World Forum for Harmonization of Vehicle Regulations

Draft Regulation on pedestrian safety

Proposal for Supplement 1 to the draft Regulation

Submitted by the experts from Germany and the International Organization of Motor Vehicle Manufacturers *

Figure 7A
Geometry of a headform to bonnet impact

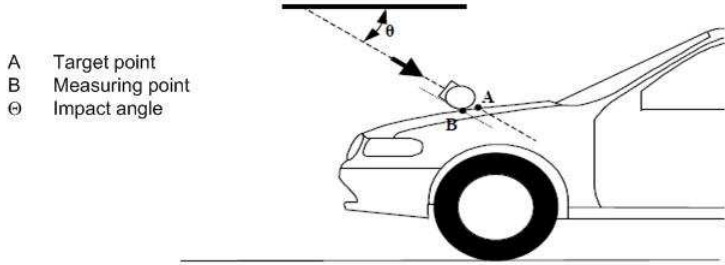
"2.22. "~~Impact~~ **First contact point**" means the point on the vehicle where initial contact by the test impactor occurs. The proximity of this point to the target point is dependent upon both the angle of travel by the test impactor and the contour of the vehicle surface (see point C B in Figure 7B and Figure 7C)."

Figure 7, shall be deleted

Insert new Figures 7A to 7C, to read:

"2.30. "Target point" means the intersection of the projection of the headform longitudinal axis with the front surface of the vehicle (see point A in Figure 7A).

- "2.41. **The measuring point for the headform test is a point in the vertical longitudinal plane of the vehicle, containing the centre of the impactor. In this plane, it is the point at which the impactor nominally first contacts the bonnet top (see point B in Figure 7A and 7B). The first contact point may differ from the measuring point as a result of the geometry of the bonnet top.**

Figure 7B
Measuring and first contact point (schematic front view) ²

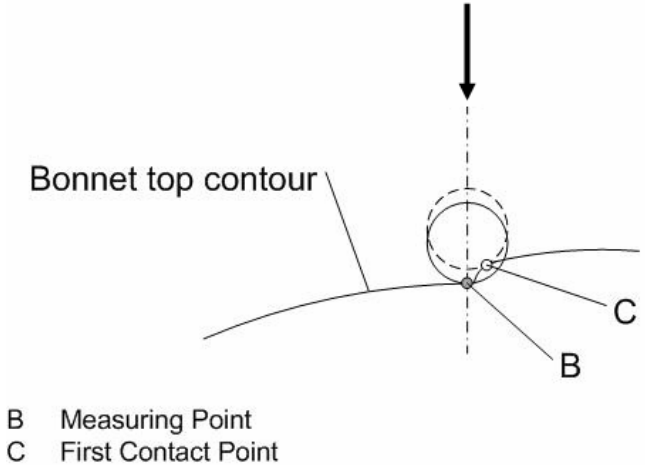
² Remark: due to the spatial geometry of the bonnet top, the first contact point C does, in most cases, not lie in the same vertical longitudinal or transverse plane which contains measuring point B.

Figure 3

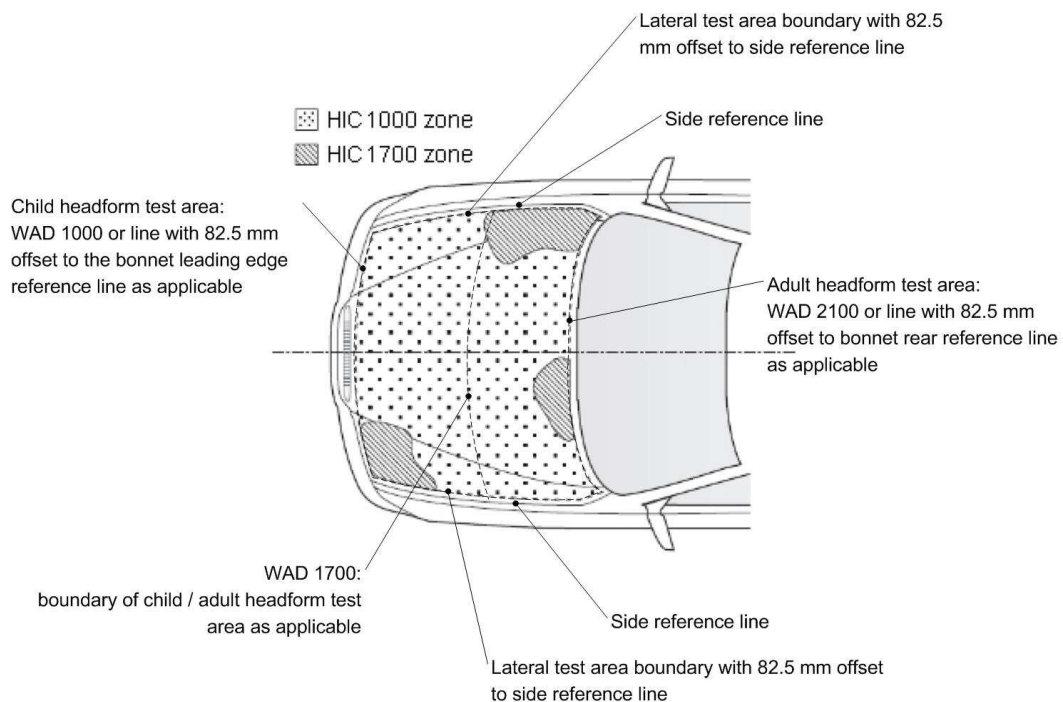
- "3.4.1. The manufacturer shall identify the zones of the bonnet top **test area** where the HIC must not exceed 1,000 (HIC1000 zone) or 1,700 (HIC1700 zone) (see Figure 3).
- 3.4.2. Marking of the "bonnet top **test impact** area " as well as "HIC1000 zone" and "HIC1700 zone" will be based on a drawing supplied by the manufacturer, when viewed from a horizontal plane above the vehicle that is parallel to the vehicle horizontal zero plane. A sufficient number of x and y co-ordinates shall be supplied by the manufacturer to mark up the areas on the actual vehicle while considering the vehicle outer contour in the z direction.

Figure 3, shall be deleted

Insert a new Figure 3, to read:
